### ADDENDUM 1

CSP 22-92

## Cavazos Elementary School Heating & Air Condition (HVAC) Improvements Funded through the Elementary & Secondary Emergency Relief (ESSER) Funds May 31, 2022

## Addendum

MD2.11A

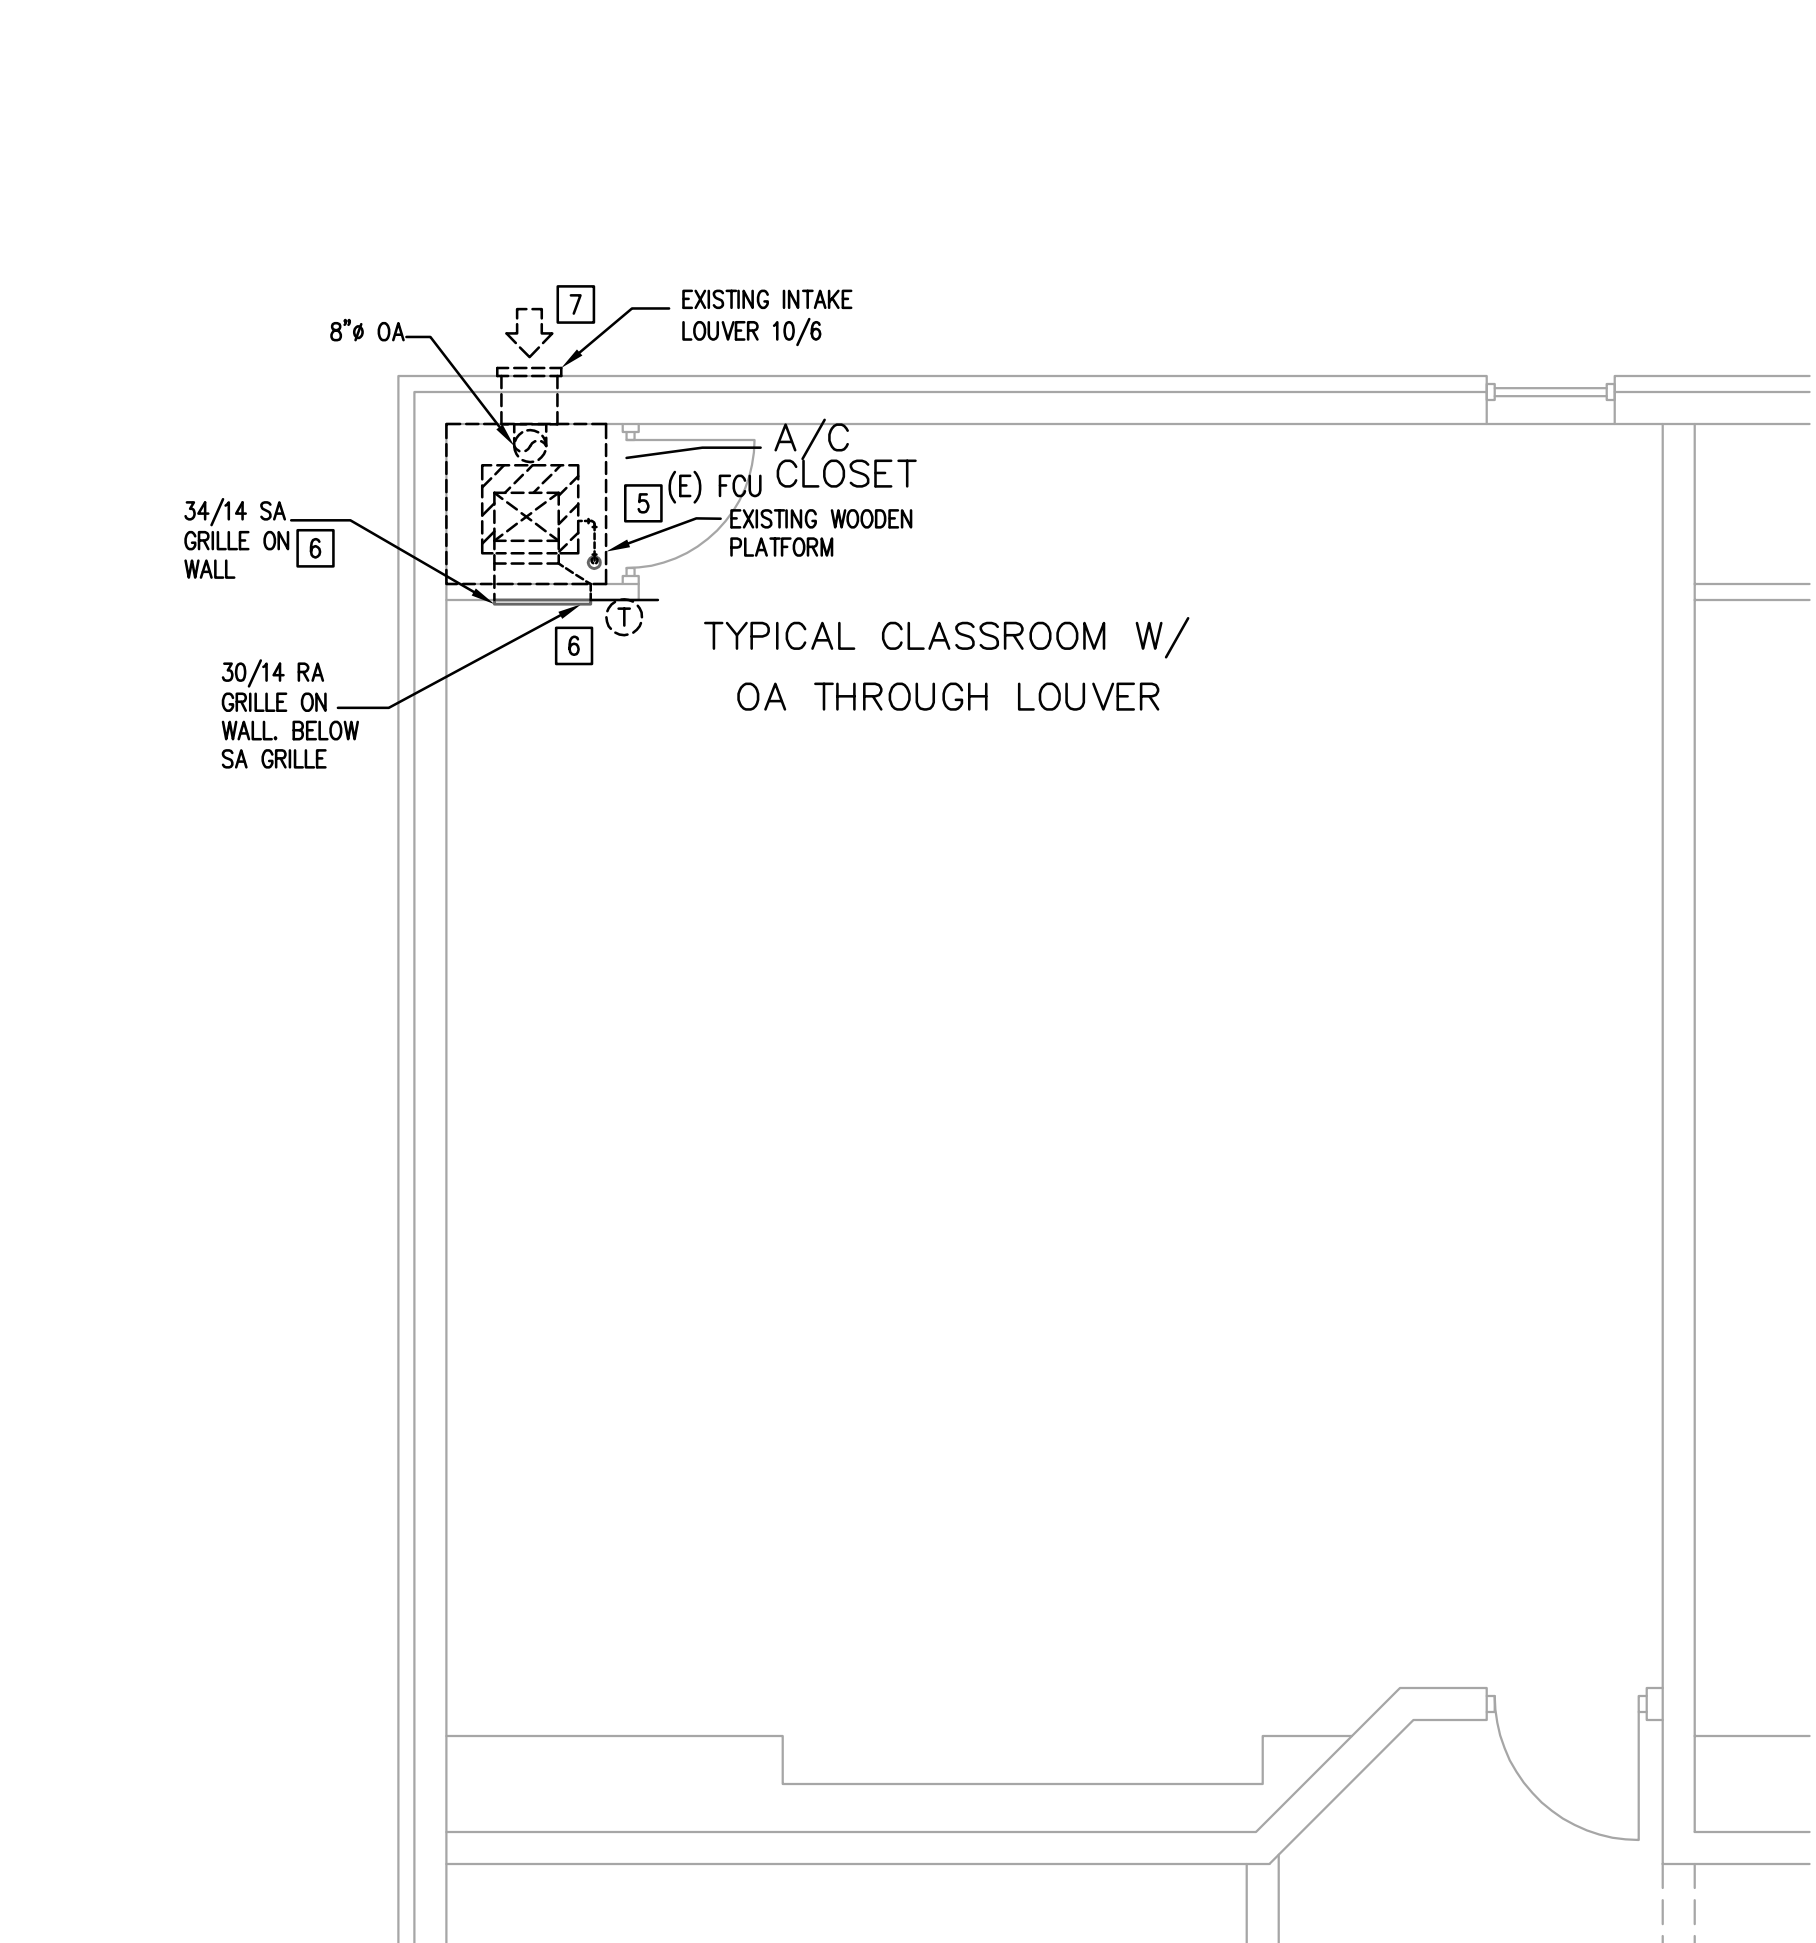
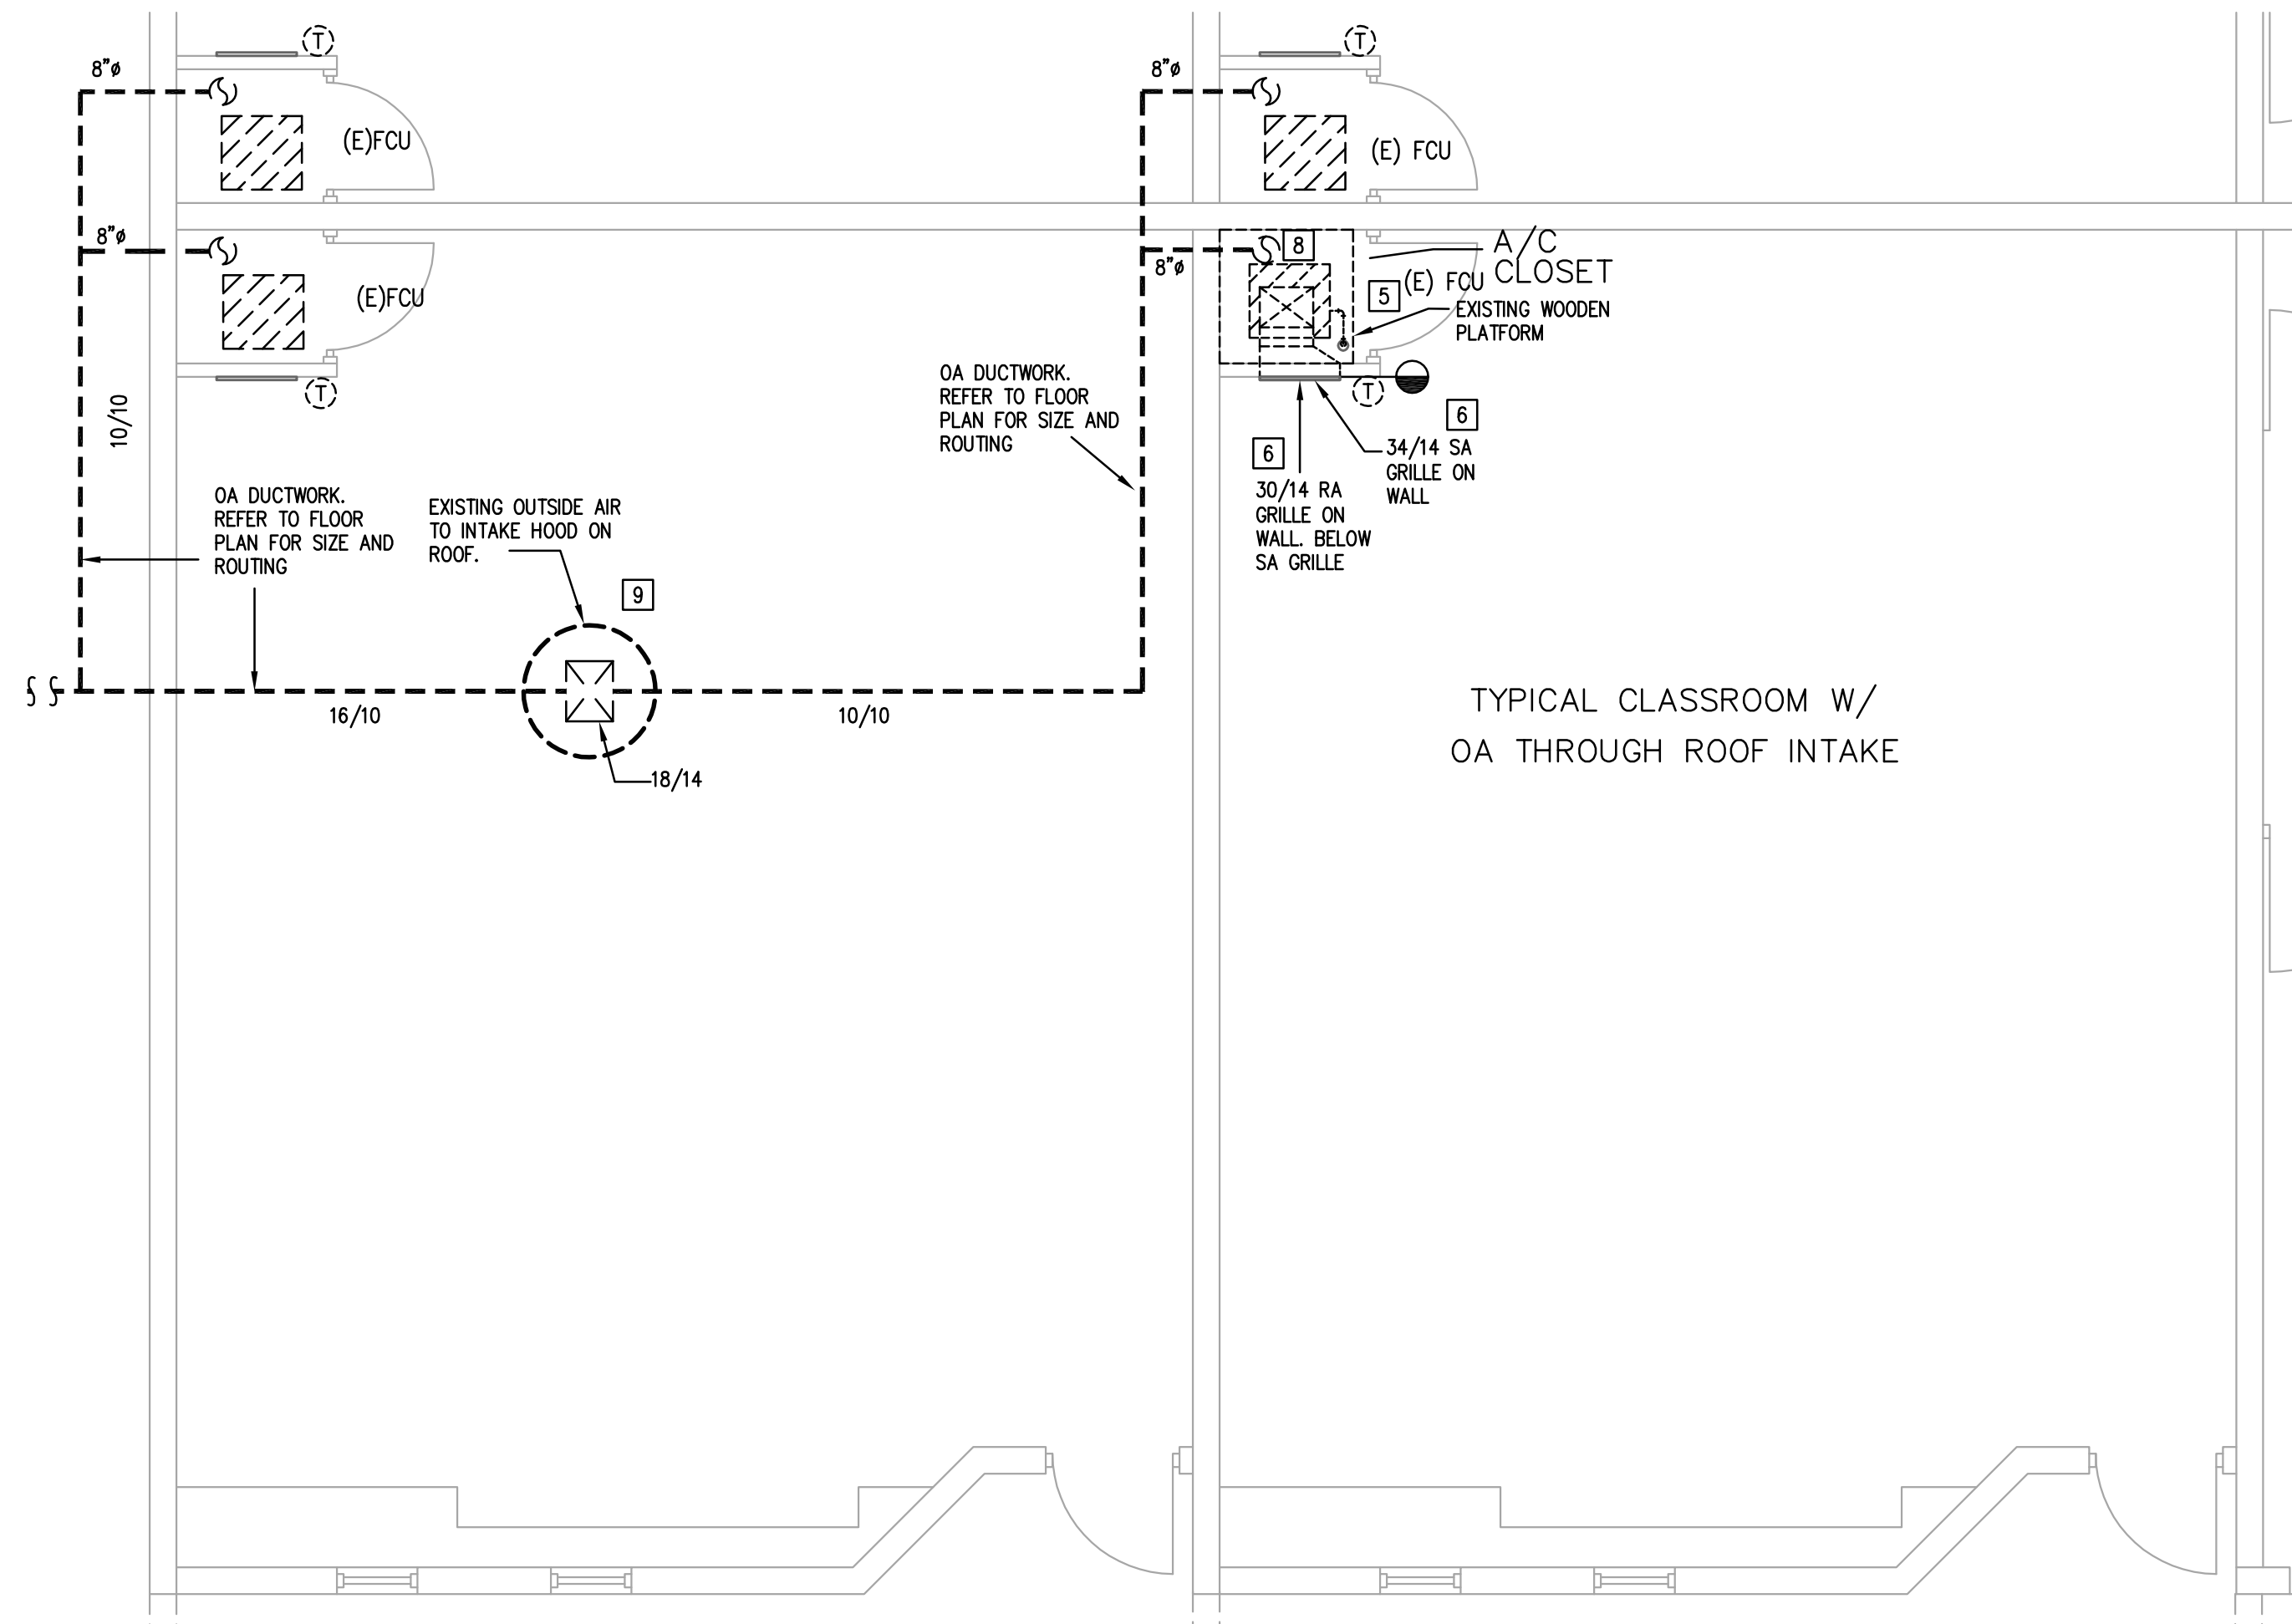
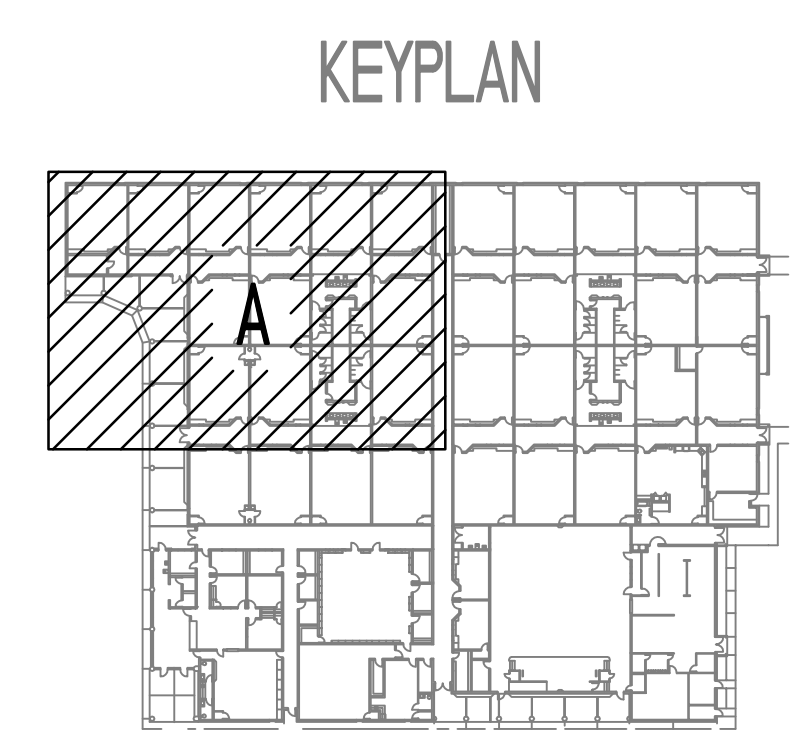
#### Sheet MD2.11A – Level 1 Mechanical Plan – Demolition – Area A

- A. Revised keyed notes 3, 4, 5.
